TRANSMITTAL OF MEETING HANDOUT MATERIALS FOR  
IMMEDIATE PLACEMENT IN THE PUBLIC DOMAIN

BWR Owners Group

Meeting with the BWROG  
to discuss steam dryer  
integrity

## BWR Steam Dryer Update

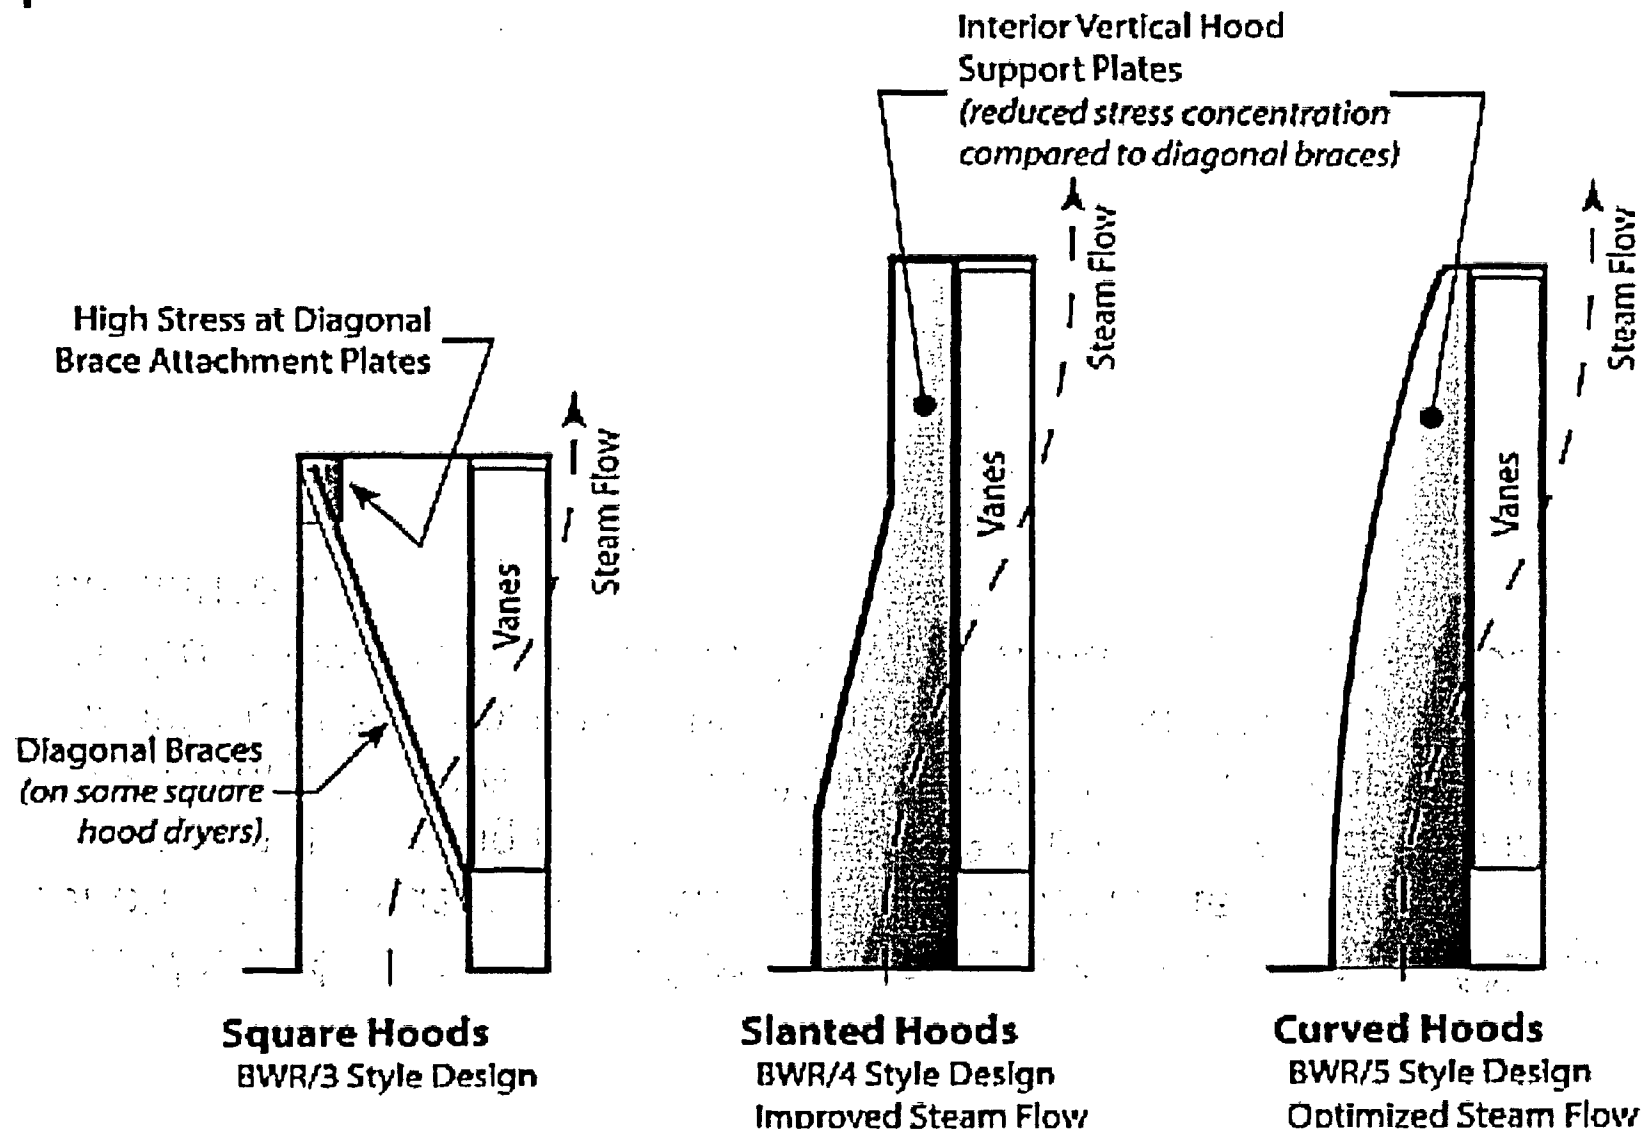
- The basis for the applicability of internal steam dryer inspection recommendations in SIL No. 644, Supplement 1 only to the BWR/3 steam dryer design with internal braces is not apparent in that experience has suggested that cracking might initiate on the interior surface of the steam dryer.

- Internal inspections recommended only for BWR/3 with internal diagonal braces
  - Interior brace attachment bracket forms localized stress concentration on inside surface of hood
  - Crack initiation observed at this location in two BWR/3s
  - Location predicted by structural analysis
- External inspections recommended for later dryer designs
  - No internal bracket forming stress concentration
  - Single-sided groove or fillet weld specified
  - Full weld penetration or backside welds not required
  - May be difficult to distinguish potential crack from crevice area in weld root

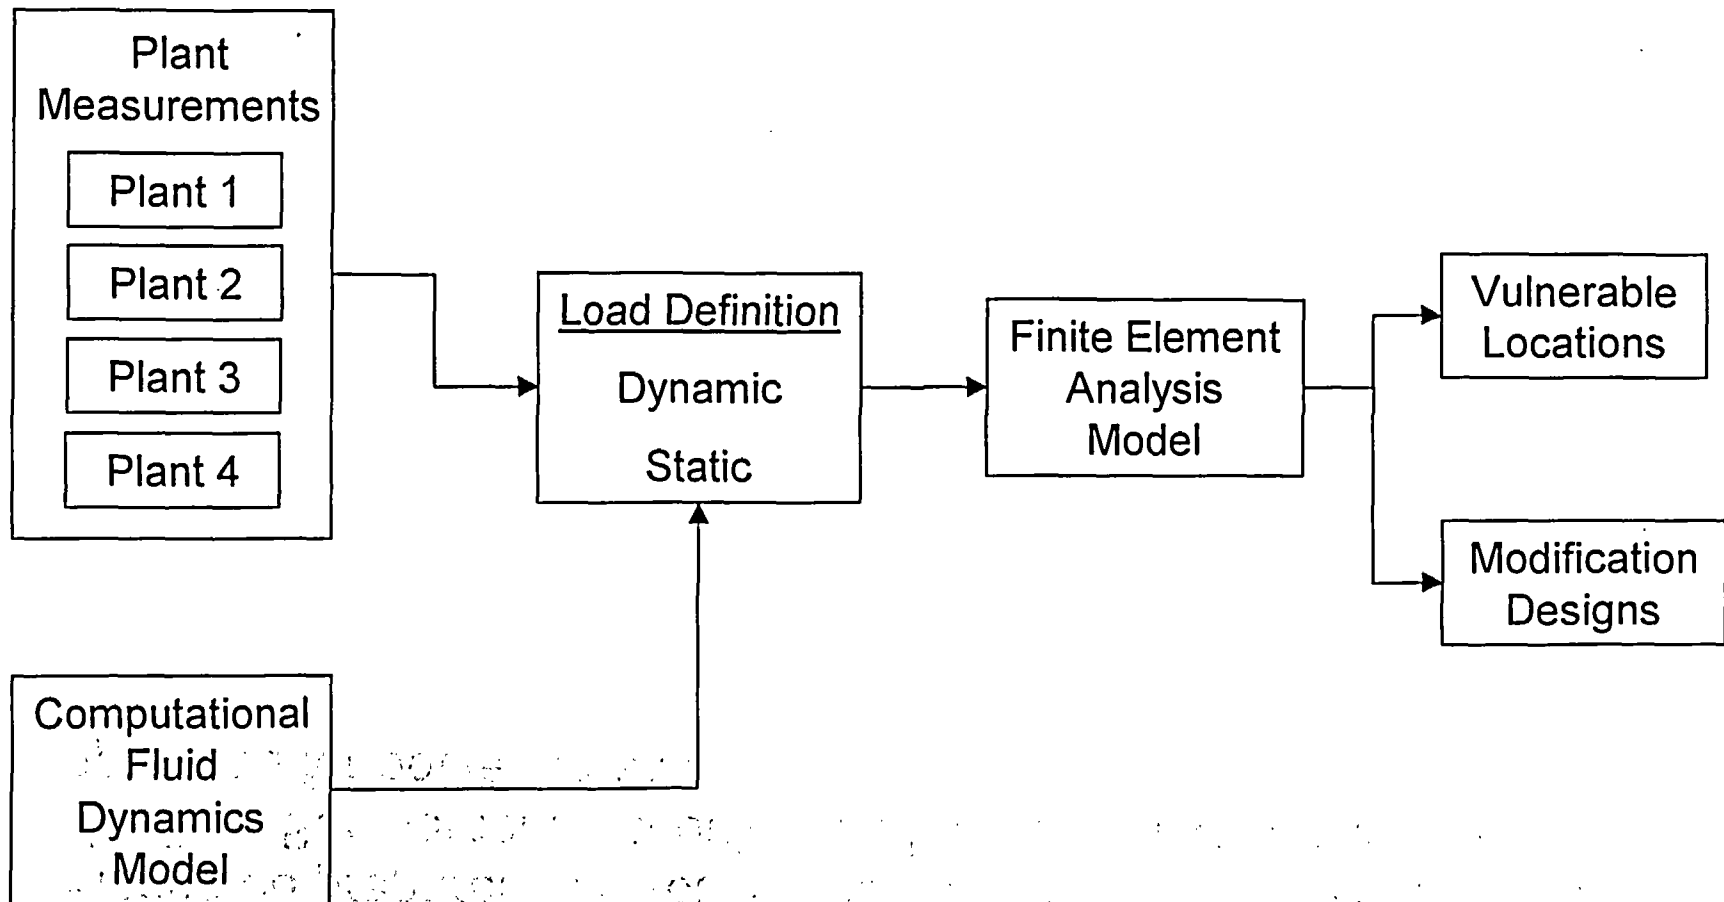
- With regard to power uprates, please be prepared to discuss what actions you intend to propose for BWRs planning to apply for future power uprates (i.e., measurement uncertainty recapture, stretch, and extended).

- GENE is developing predictive analytical techniques in support of future power uprates
  - Dynamic load definition based on in-plant measurements of several instrumented dryers
  - Computational fluid dynamics model for detailed static load distribution
  - Finite element structural analysis model of entire dryer
  - Benchmark against OLTP conditions
  - Identify vulnerable components
- Process applicable to any size power uprate
- Experience with initial EPU applications may justify simpler analysis for stretch, MUR uprates
